REVISIONS	
A B-8-2015	PLANNING NOTES: ROOF REDESIGNED: SIDE WINDOWS DELETED: EXTENSION AT SIDE MOVED TO GIVE A MINIM. OF 150mm TO PARTY BOUNDARY: BEDROOM WINDOW RE-INSTATED TO FRONT

PROJECT:- Extension		
DRG No.	14L06A	Sheet No. 1
SCALE:-	1 : 50	
CLIENT:-	Mr & Mrs Murphy.	
SITE:-	59 Linkstor Rd., Liverpool

Proposed Front Elevation

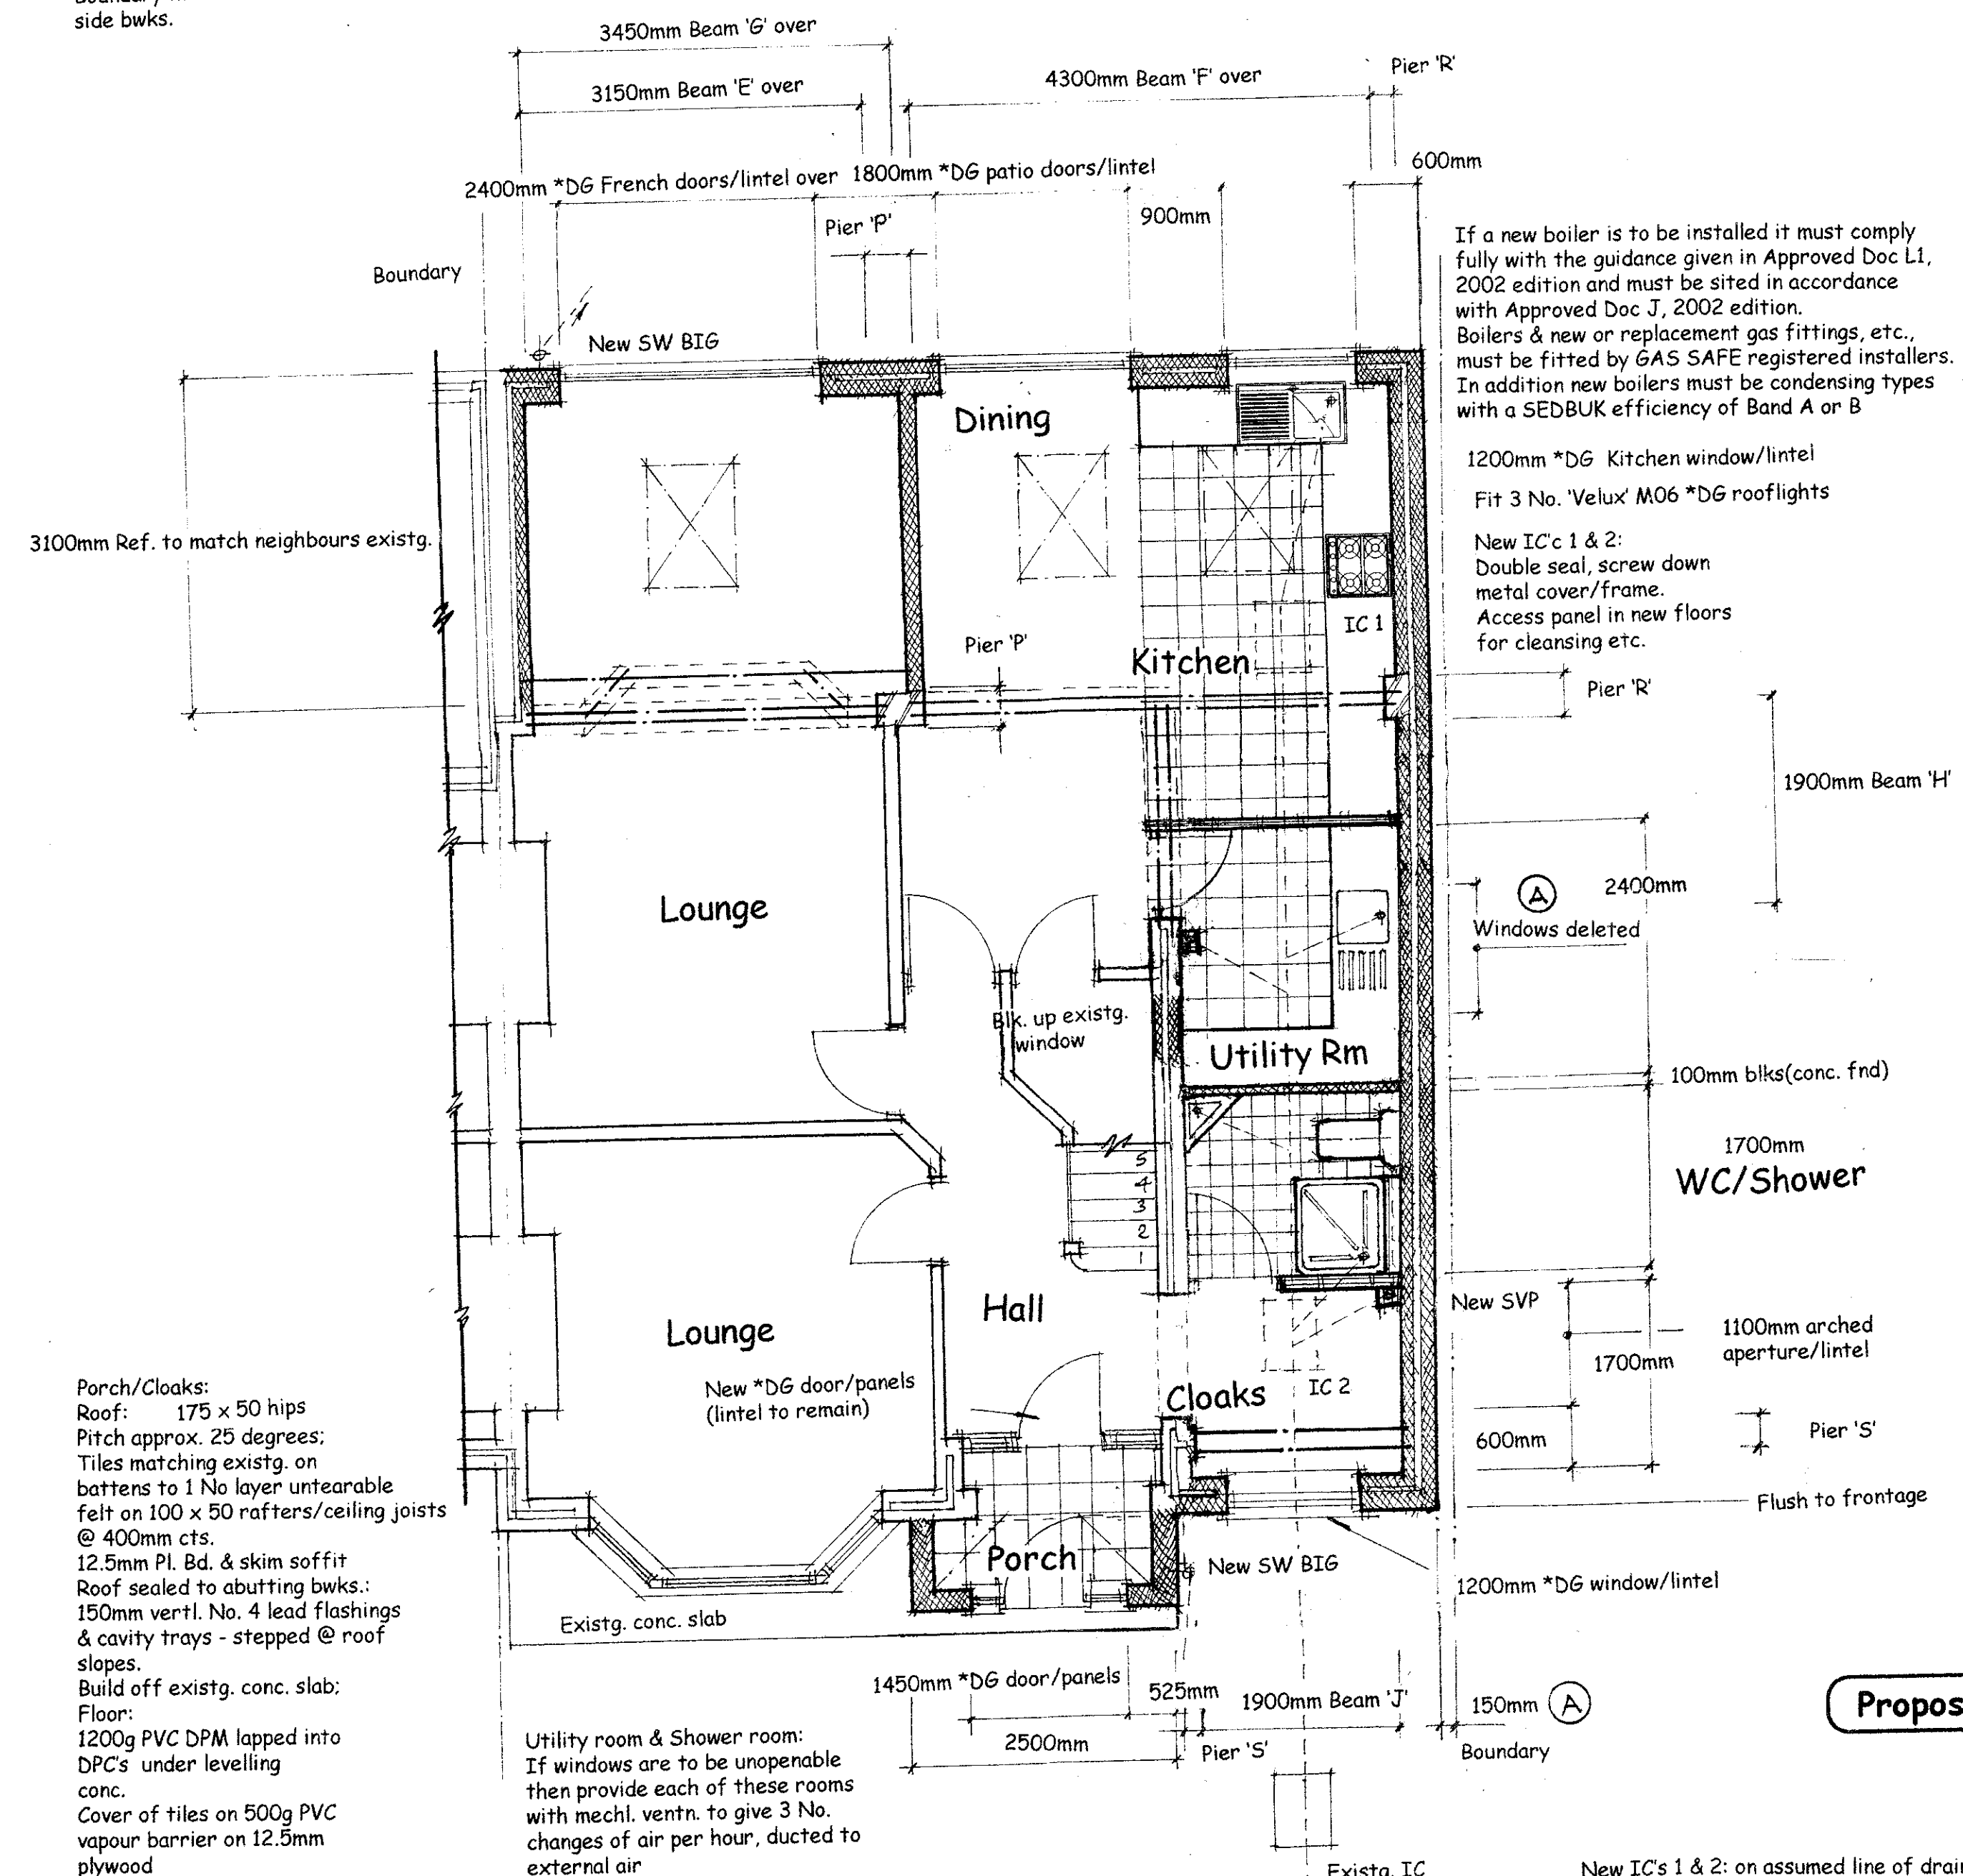
Roof redesigned:
Boundary now 150mm from
side bwks.

Side windows deleted:

Roof redesigned:
Boundary now 150mm from
side bwks.

Proposed Side Elevation

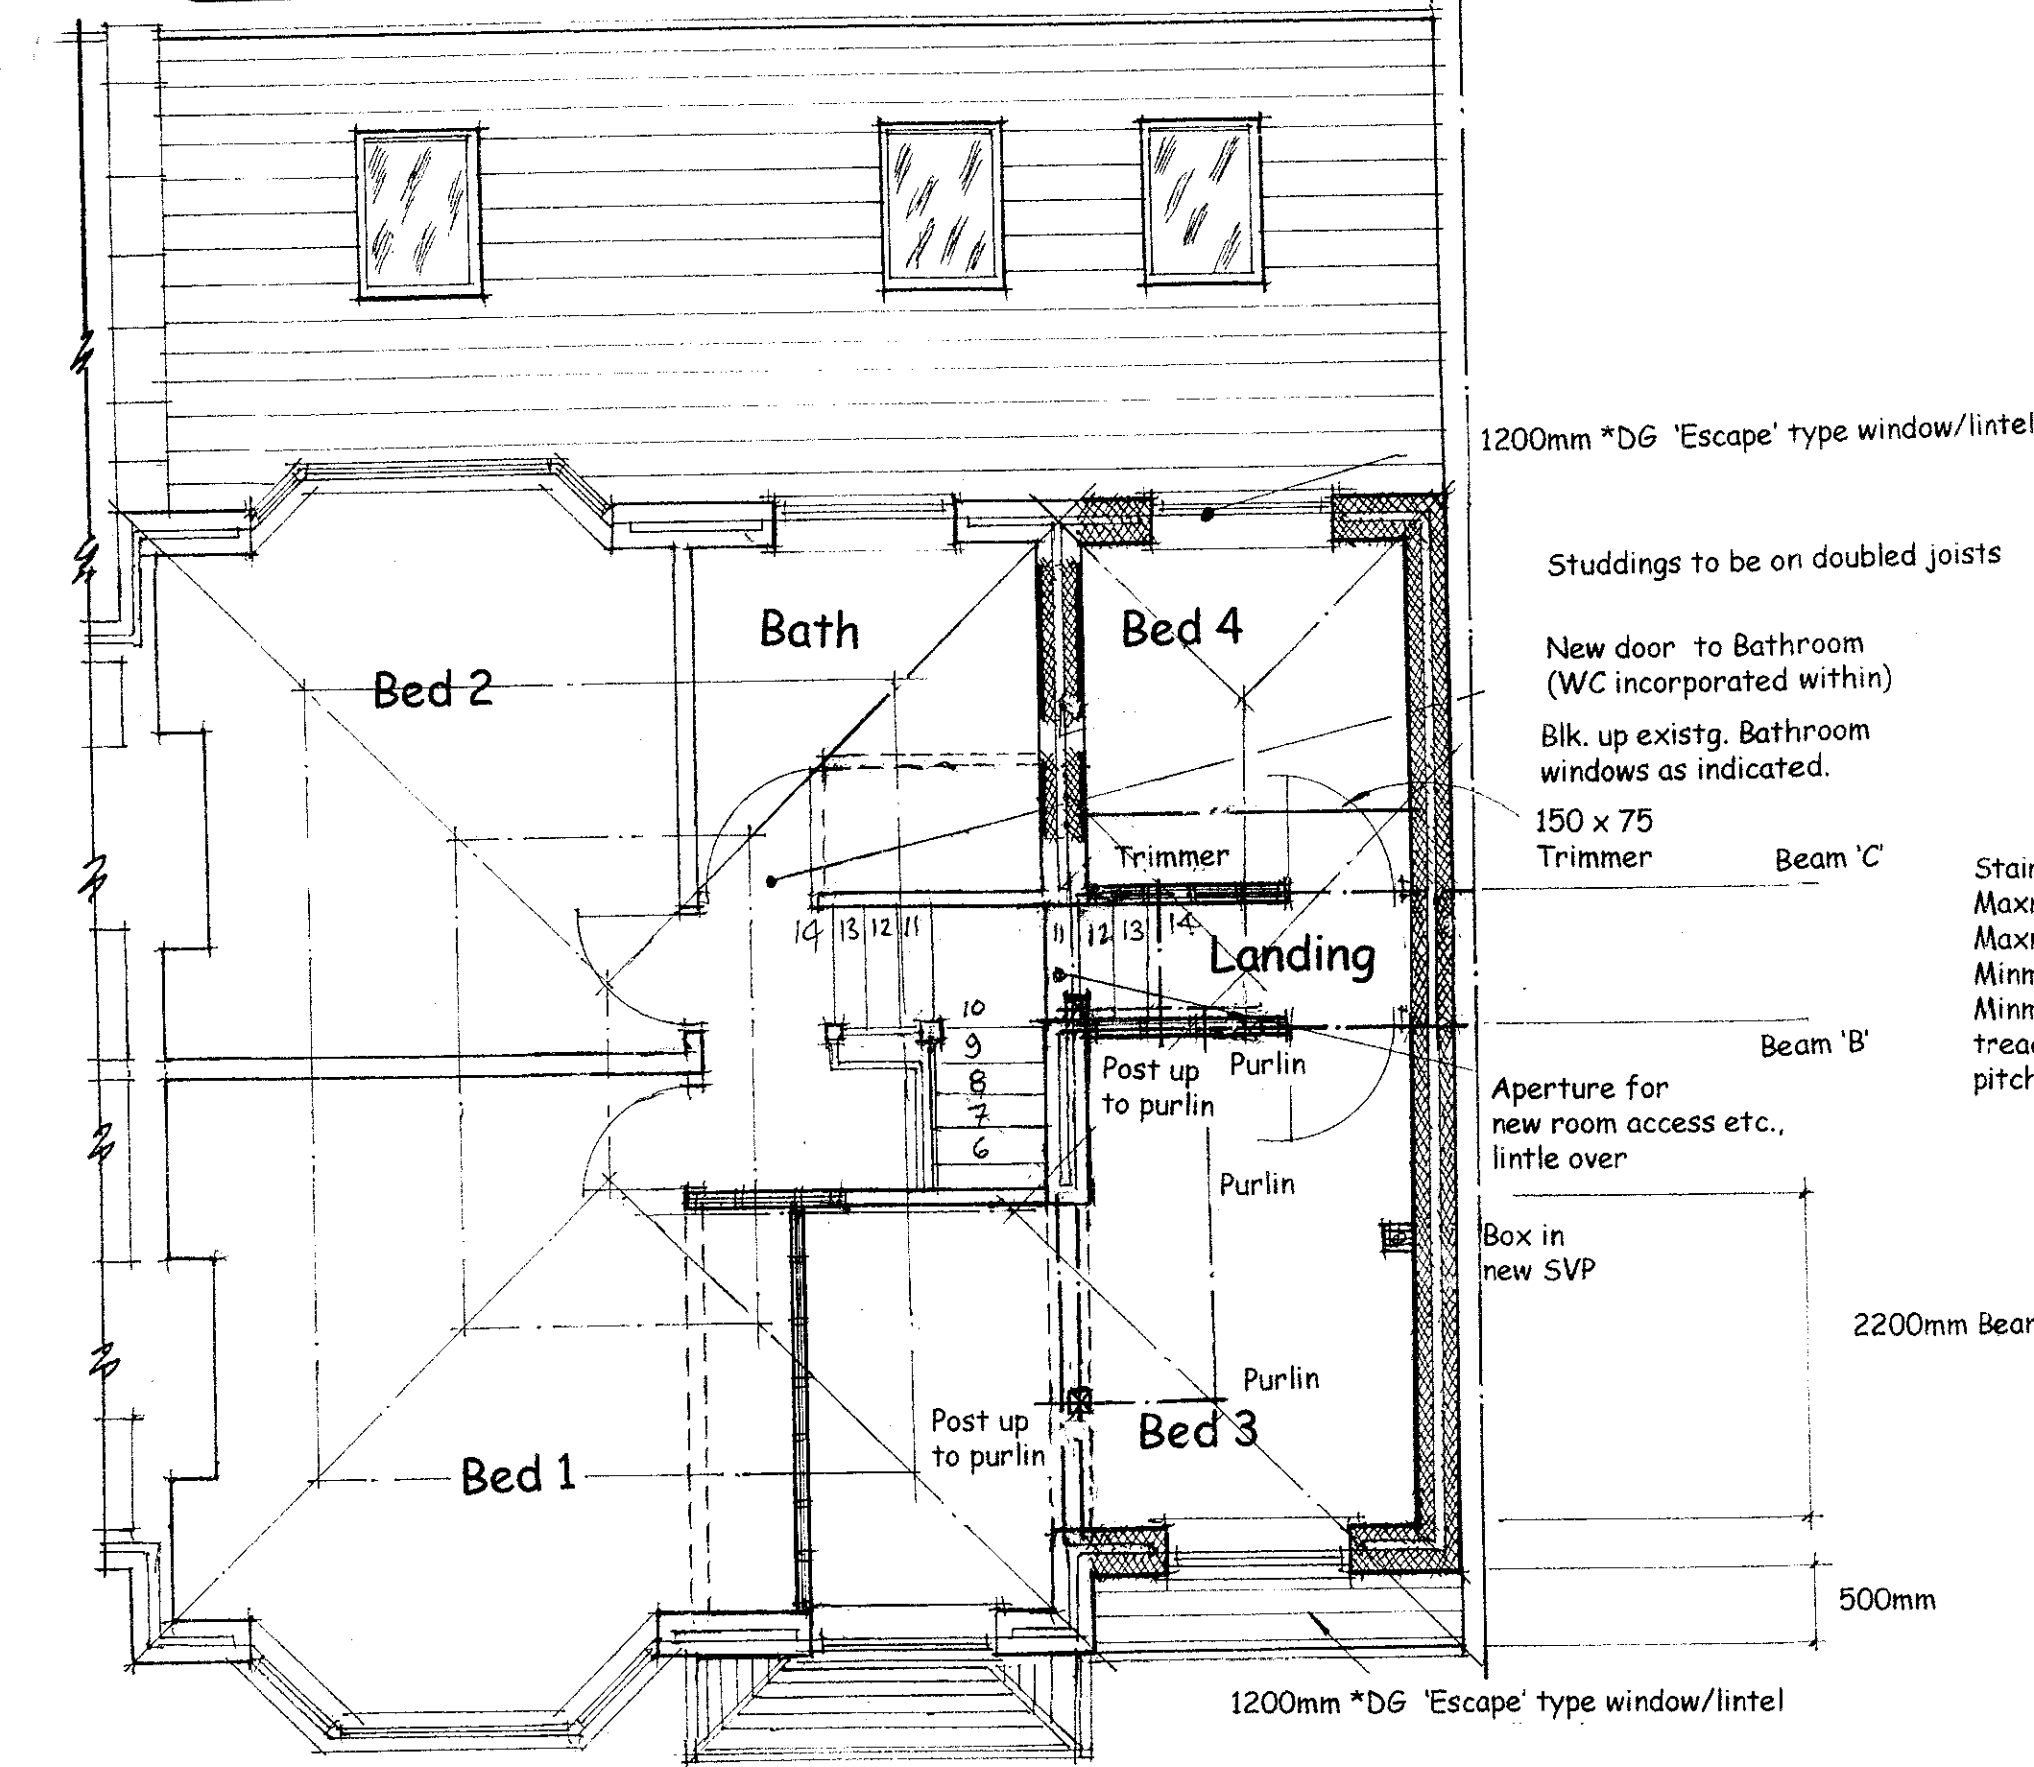
Roof redesigned:
Boundary now 150mm from
side bwks.
Side windows deleted:

Roof redesigned:
Bedroom window re-instated;
Boundary now 150mm from side bwks.
